## **ZONING CHANGE REVIEW SHEET**

**CASE:** C814-06-0233 – Wildflower Commons  
Planned Unit Development

**ADDRESS:** 4700 – 5200 Block of SH 45

**ZONING FROM:** SF-2; GO      **TO:** PUD      **AREA:** 265.678 acres

EXHIBIT B  
AND USE PLAN

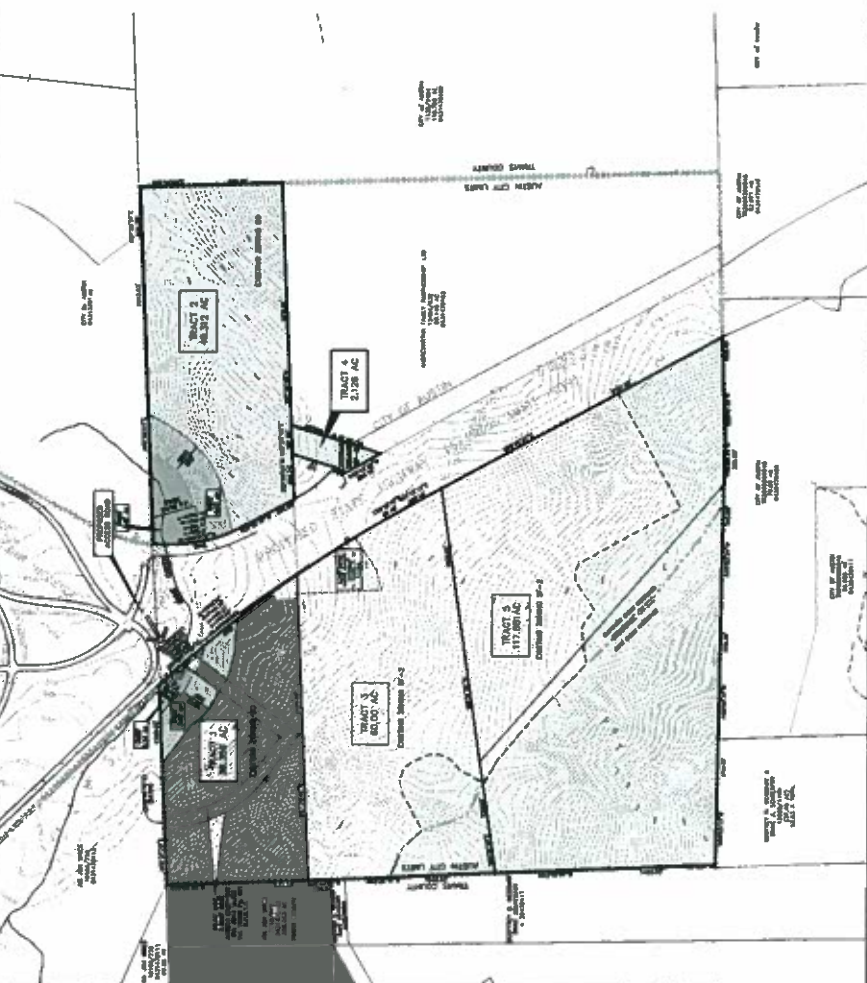
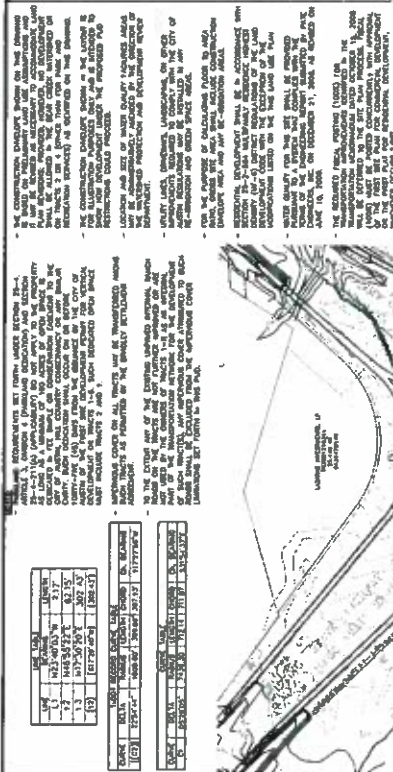
The Staff recommendation is to grant planned unit development (PUD) district zoning with the conditions of the Environmental Board Motion 101508-3A, as shown in Attachment A; incorporating the Exterior Light Pollution Reduction Techniques, Exterior Design / Heat Island Reduction Requirements as illustrated in Attachment C; and as shown in the PUD Land Use Plan provided in Exhibit B.

EXHIBIT B-1  
PUD LAND USE PLAN (REC'D 2.5.09)

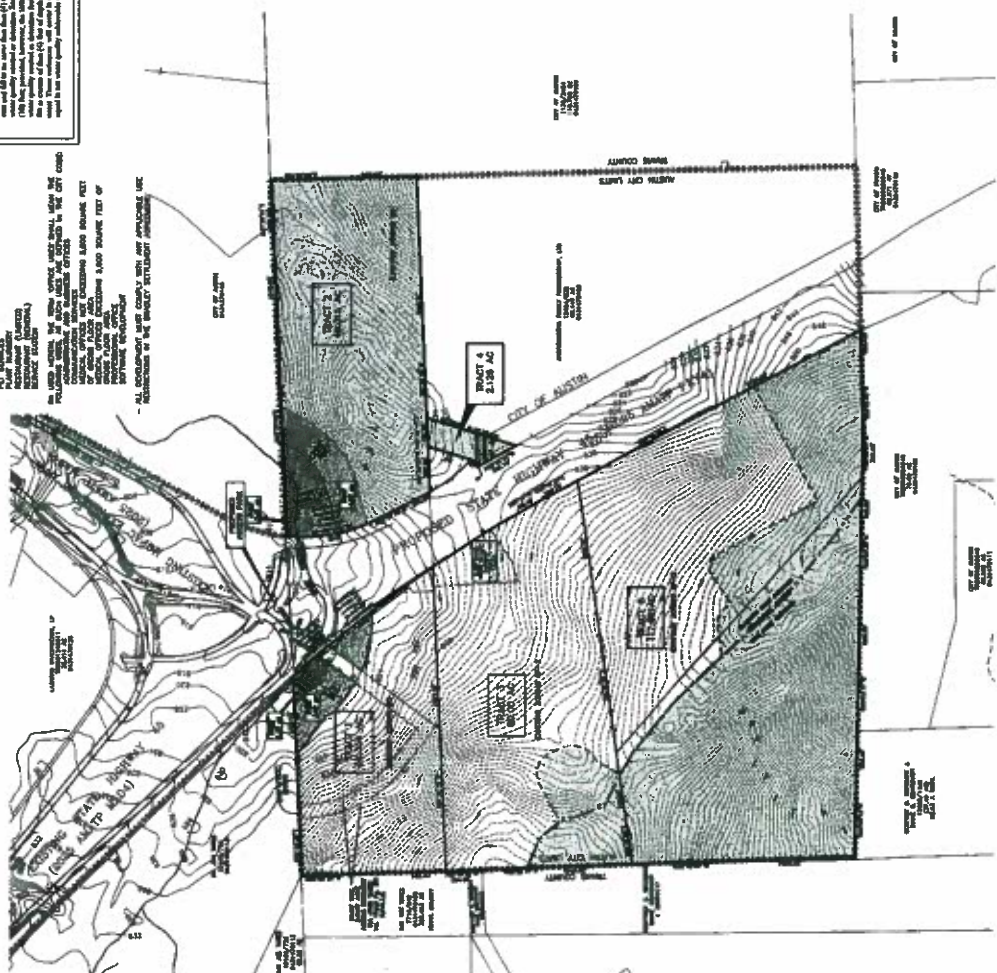
A revised PUD Land Use Plan was received on February 5, 2009 and distributed for review by the Law Department and the Watershed Protection and Development Review Department. Based on an initial Staff review, some of the notes on the Plan have been altered and additional notes have been provided. Please refer to Exhibits B-1 (PUD Land Use Plan received 2-5-09) and B-2 (Applicant's revisions to the PUD Land Use Plan).

1. Under Code Modifications and Variance letter (C) "If the total areas utilized for cut and fill in excess of four (4) feet in depth for roadways, parking, driveways or site development connection purposes is greater than two (2) acres, a variance under sections 25-8-341(A)(2) and 25-8-342(A)(2) shall be required." was added.
2. On letter D under Code Modifications and Variances "; provided, however, the total amount of area used for water quality control or detention facilities that contains cut and fill in excess of (4) feet of depth shall be limited to three (3) acres" was added.
3. A new note was added that reads:

4. A new note was added that reads: "All development must comply with any applicable use restrictions in the Bradley Settlement Agreement."
5. A new note was added that reads: No "Major Employer", as defined in the Bradley Settlement Agreement" may ever lease or occupy all or any portion of an office building located on any portion of any of the tracts.

6. On the first note on the 2<sup>nd</sup> column the portion of the note that read "the construction envelope shown on the drawing is based on preliminary land use assumptions and plan revision; provided, however" as removed.

7. The note that began with "The construction envelope shown on this drawing is based on preliminary land use assumptions and may be revised if necessary to accommodate land plan revisions" was revised to read "The construction envelope may be modified as long as such modifications are consistent with the restrictions contained herein"

8. On the code modification and Variances chart all of the "intro's" that begin with "in accordance with section 25-8-41 and the Land Development Code were removed.

9. In the Code Modification table letter G(1) was revised to remove "and 25-8-519 (Construction of Ordinance)".
10. On the Land Use table, "Multifamily residential (attached condominium residential use shall be allowed)" and "Townhouse residential" were added to the Additional Prohibited Uses column under Tracts 1, 3 and 5.

11. A new sentence was added that reads "Such transfers shall be made concurrently with the dedication of open space required herein." was added to the note detailing impervious cover in Bradley.

12. The note that reads "Residential development shall be in accordance with section 25-2-564" was deleted
13. On the Land Use table that details the tracts. Under the Site Development Modification Column the regulations in tracts 1, 3 and 5 were revised to be bullet points and say:

**Map 1: Location Map for Critical Environmental Feature Setbacks  
(Revised - 07-07-2008)**

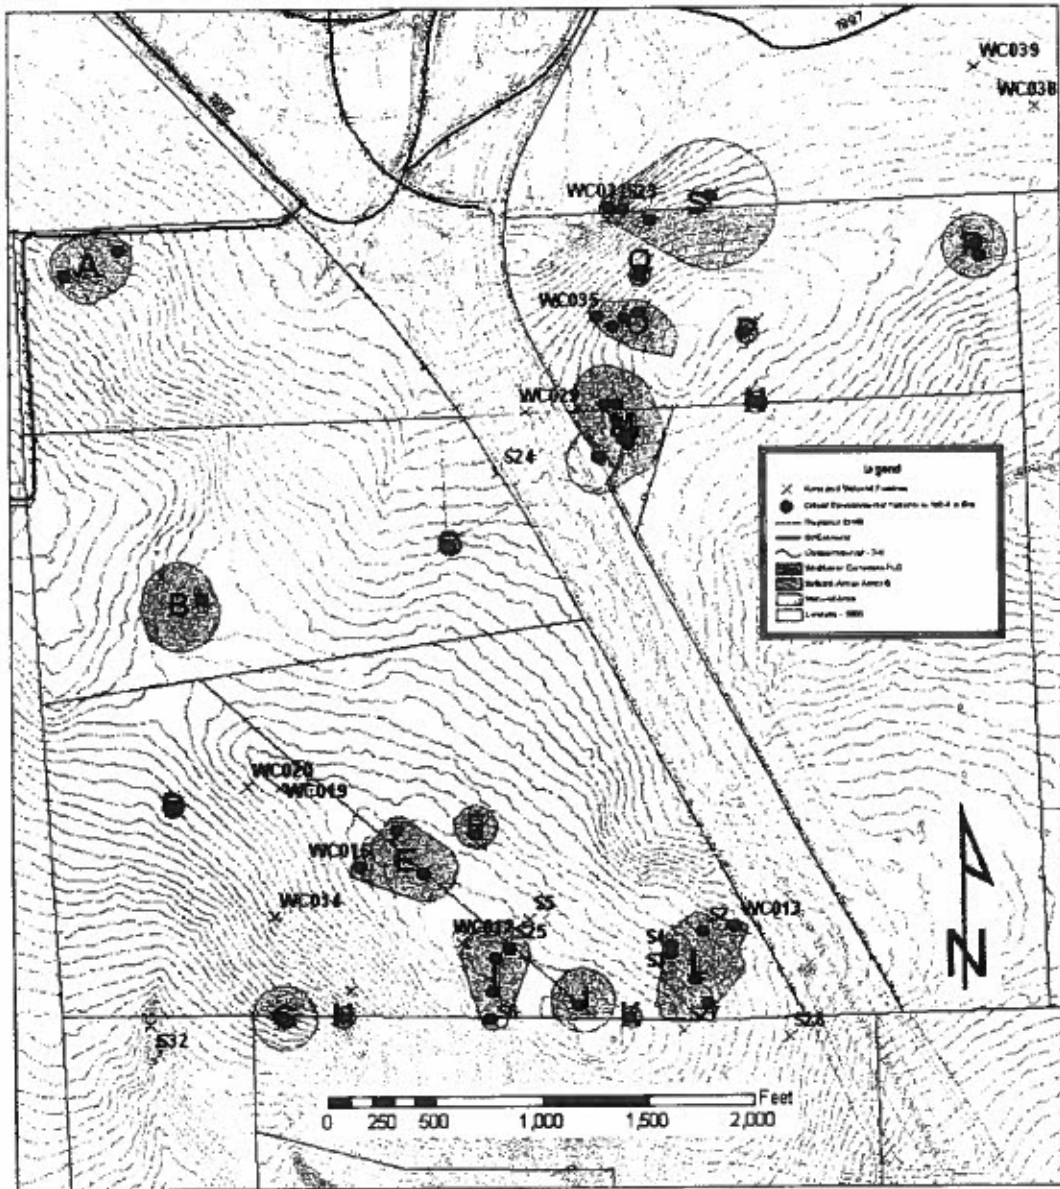
**SUBJECT:** Corrections to ERM's August 22, 2007 memo regarding Critical Environmental Feature setbacks of Wildflower Commons.

Based the surface drainage patterns, 2-ft topography, the type of feature, the feature's size and the density (or clustering) of features, ERM staff is recommending protecting the critical environmental features with 19 critical environmental feature setback areas (Labeled A thru S). The attached map shows the location of the setback areas. ERM staff is recommending that the CEFs and their associated setback area (or buffers) are documented within the PUD ordinance along with the following Land Development Code (LDC) requirements from Section 25-8-281.

1. No residential lots may include a CEF or be located within 50 feet of a CEF.
2. Setback areas must be established to protect all CEFs. Although the LDC allows a portion of the CEF buffer to be included in a residential lot, I do not recommend that this be allowed. Residential lots should not include any portion of a CEF buffer. Setbacks must comply with the setback area has stated in Table 1 and shown Map 1. ERM is willing to revise setback areas listed in Table 1 and shown on Map 1 during PUD process, if the applicant provides more detail information to ERM staff such has 1-ft topographic survey that better delineates the catchment areas and a hydrogeologic assessment the features that better evaluates it recharge potential.
